New Albany Planning Commission Meeting
Minutes - June 17, 2024 - Approved

**DONATOS MULTI-TENANT BUILDING
FINAL DEVELOPMENT PLAN**

**WRIGHT PATT
FINAL DEVELOPMENT PLAN**

August 2023 (Figure 1)

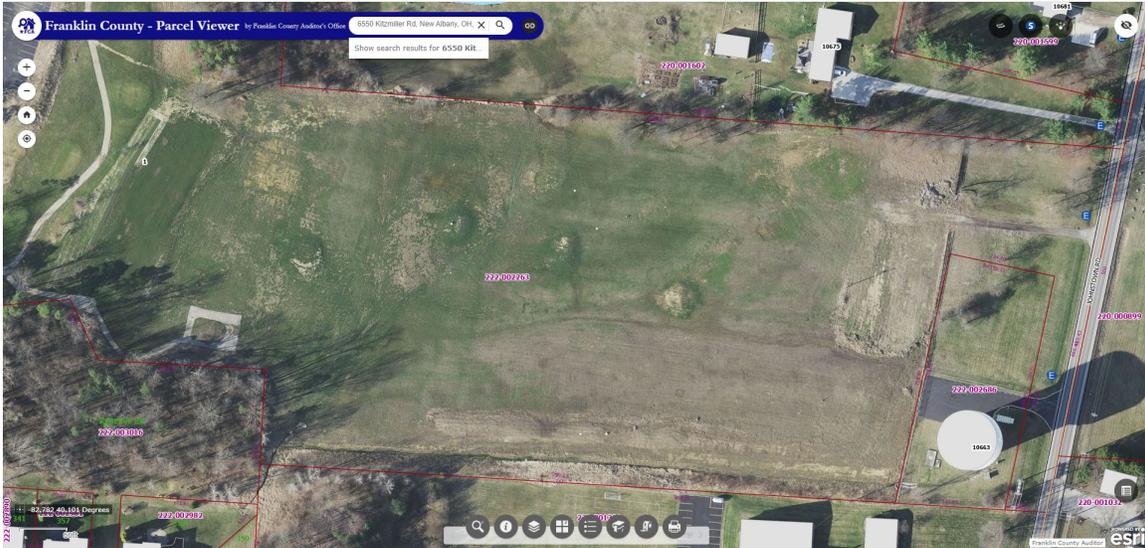
The images below show the existing conditions when the final development plan was approved in 2009 (Figure 2) and current 2023/2024 conditions (Figure 1).

Planting Plan

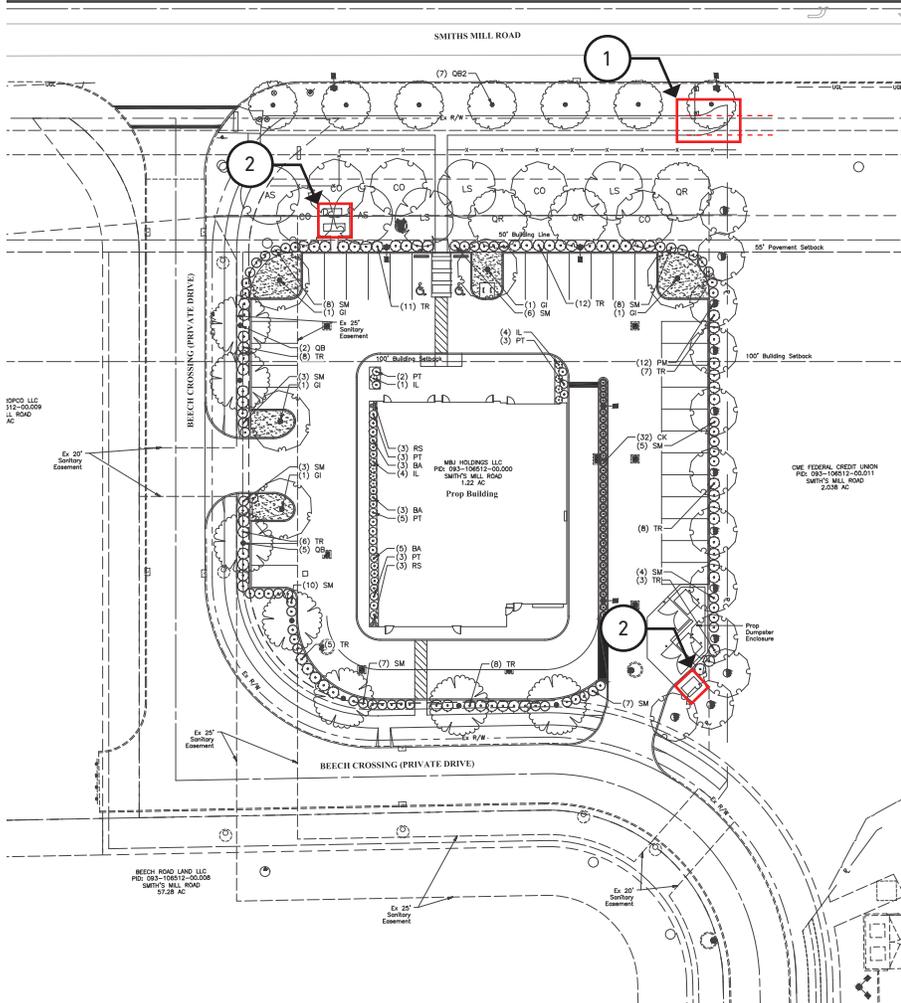
1. Reevaluate leisure trail alignment along Smith's Mill Road. Proposed condition to align with adjacent site. See diagram.

2. Provide evergreen shrubs (36" in ht.) to screen utilities, as marked. See diagram.

1. The city's landscape architect comment shall be addressed as part of permitted, subject to staff approval:
 - a. That the applicant modifies the proposed leisure trail along Smith's Mill Road to align with the adjacent site.

- b. Provide evergreen shrubs that are 36" in height to screen utilities.
2. That staff can review changes or modifications to the proposed patio that would not include changing the size or location.

Site Plan

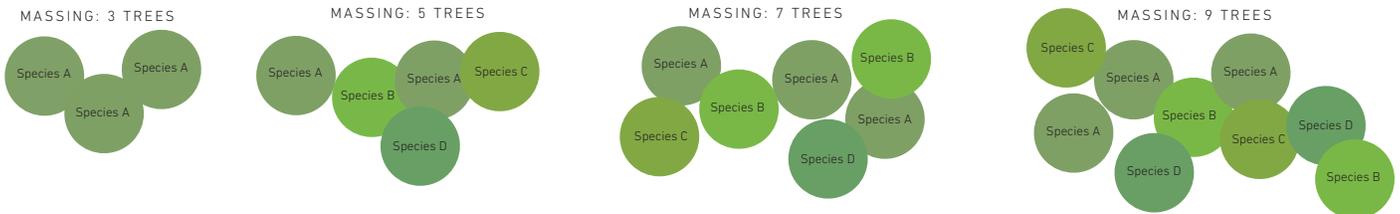
1. Realign the access drive adjacent Johnstown Road to create a consistent transition from the existing drive at the neighboring parcel. See diagram.
2. Realign the proposed parking to follow the building and pavement setback with the shifted access drive, and accommodate parking requirements. See diagram.
3. Realign proposed pedestrian connection from Johnstown Road to safely connect across the recommended access drive. See diagram.
4. Provide a pavement marking plan for review of vehicular circulation at access drives and drive through lanes. Resubmit plans. See diagram.

1. The City Landscape Architect’s comments must be addressed, subject to staff approval;
 - a. Realign the access drive adjacent Johnstown Road to create a consistent transition from the existing drive at the neighboring parcel.

Sign A:

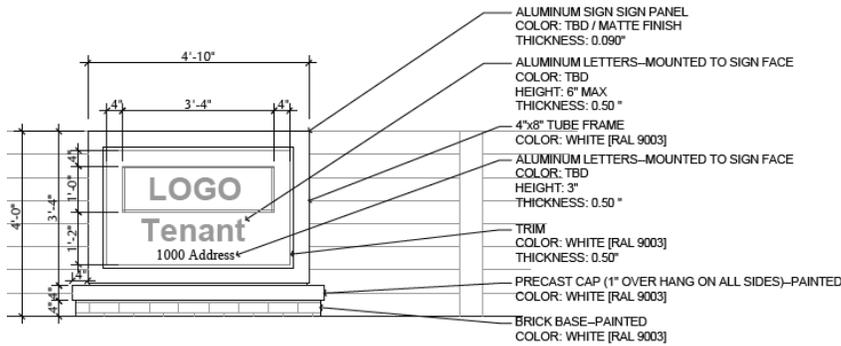
This is a monument sign that is installed at the site entrance along Woodcrest Way. Zoning text section III(I)(2) states that the permitted sizes, designs, colors, shapes, and other specifications for ground signs shall be consistent with the 2013 Trust Corp Signage Recommendations Plan. The existing sign does not meet the design standards for monument signs therefore, a variance is necessary in order to allow the sign to remain on the property. The city code prohibits electronic signs and the sign exceeds the maximum number of colors allowed per city code (4). Therefore, three variances are necessary to allow the sign as installed:

Sign B:

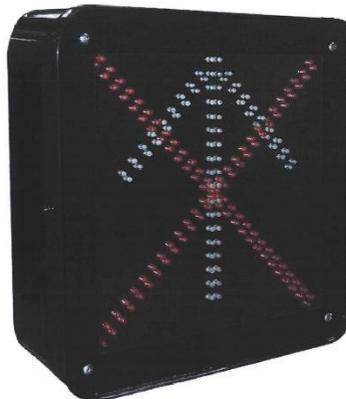
The applicant installed additional directional signage on the clearance bars which are above lanes leading to the car wash. These signs were not submitted for review as part of the final development plan application and are considered unregulated. One component of these directional signs are three electronic arrows as shown in the image above. C.O. 1169.04 states that electronic signs are a prohibited sign type therefore, a variance is necessary in order to allow the signs to remain on the site.
